QUESTION	AE Response	VA Response
1.	Will the General Contractor be responsible for maintaining the sprinkler system and vegetation around the building?	The General Contractor is responsible for protecting the sprinkler system and vegetation from damage or destruction throughout the course of construction. Any disturbed vegetation and/or damaged sprinklers must be repaired/ restored to preconstruction condition following final completion.	Contractors may remove vegetation and temporarily plant it along the western property line and re-planted after the construction is complete. Sprinkler system is no longer used and does not need to be replaced.

1 LEVEL 1 FLOOR PLAN - ALTERNATE 1

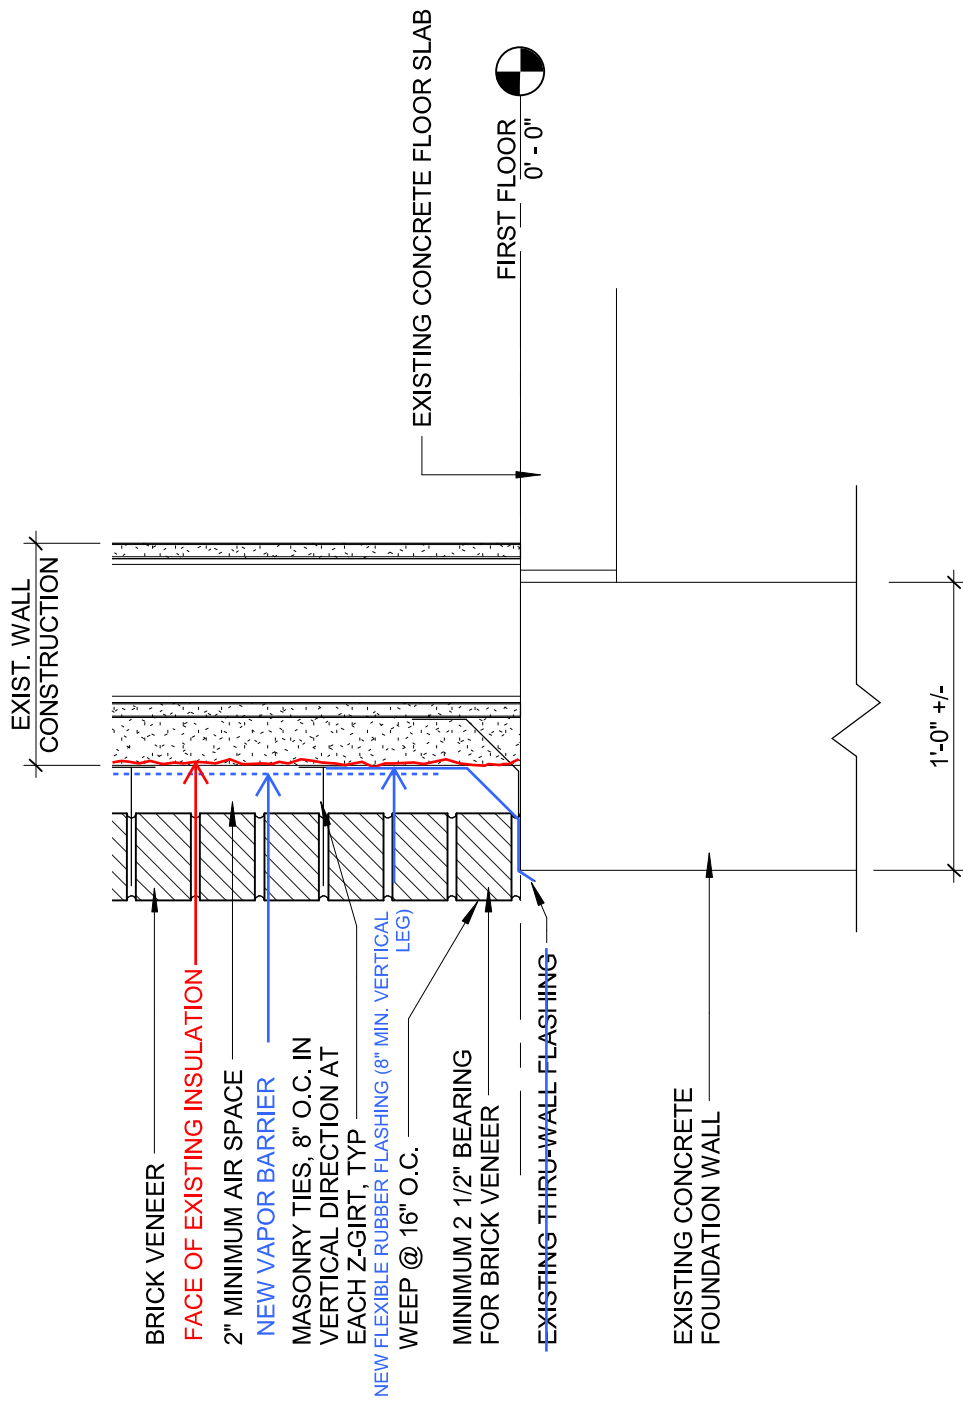
2.	There does not appear to be sufficient brick ledge at the windows on the North and Northwest side of the building. How should we handle this situation?	General Contractor is responsible for verifying existing condition is sufficient to provide required minimum bearing. All bids should include the cost of metal panels instead of brick installed below the windows as indicated in the attached existing floor plan excerpt.

B ENLARGED DETAIL - BOTTOM OF WALL

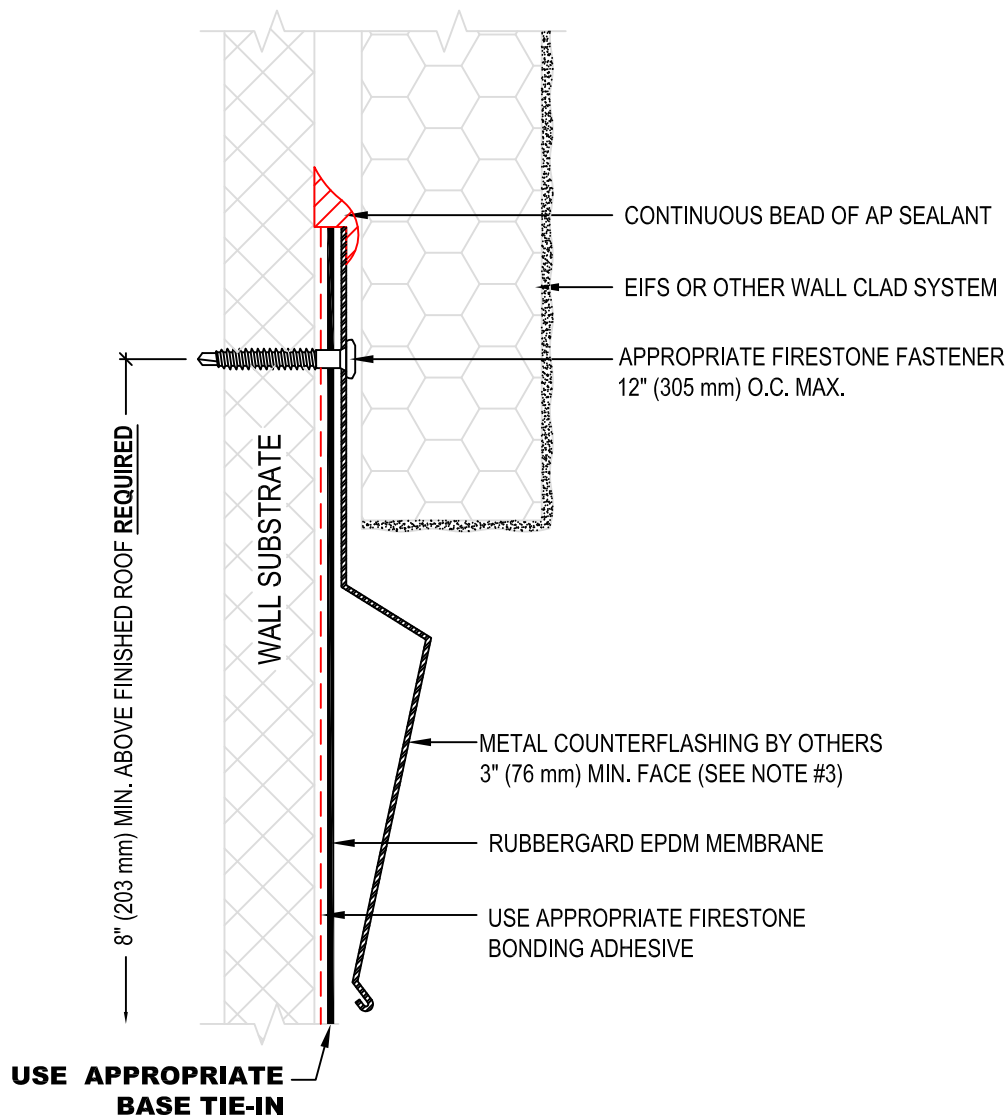
3.	There was discussion regarding the reuse of the flashing at the bottom of the building. Should this flashing be reused or replaced with new?	The intent is to reuse the existing thru-wall flashing as shown on the construction documents provided that it is in an acceptable condition and not damaged during the course of demolition. All existing <u>stainless steel sill</u> flashing is to be removed completely and replaced with continuous flexible rubber flashing membrane with 8" minimum vertical leg. Provide vapor barrier outboard of existing spray foam insulation and lap over new flashing membrane. See attachment.

FB-8B

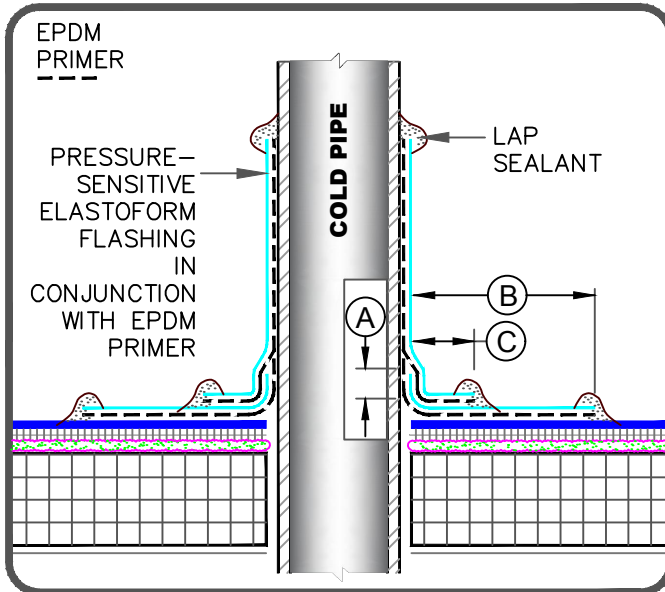
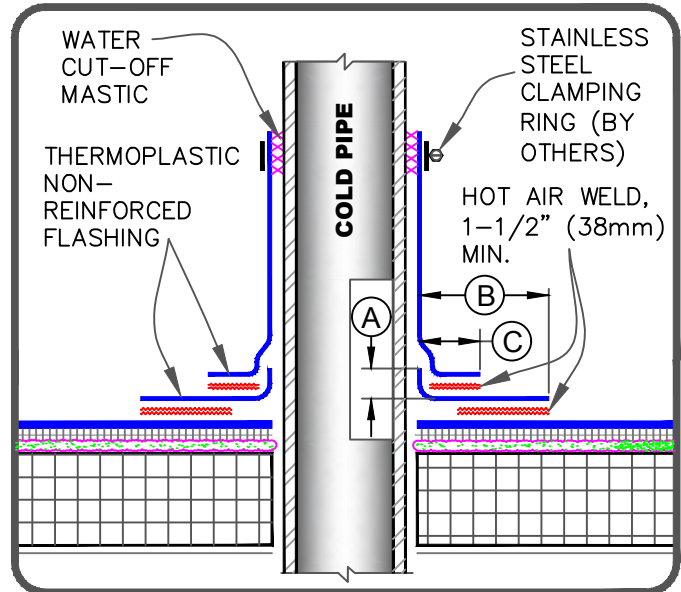
9.	Could you please confirm how we are going to terminate at the metal panel guardrail once installed on the existing roof?	Use a metal panel manufacturer-approved break metal trim piece like the one shown in detail F/A301. Additionally, provide a prefabricated, reinforced 60 mil square pipe boot in conjunction with EPDM primer around each guardrail post penetrating the roof and apply continuous bead of lap sealant at all edges. See attachments for reference. The square boot should be installed similar to the round boot detail (FB-8B).	
	VA GENERATED ITEMS
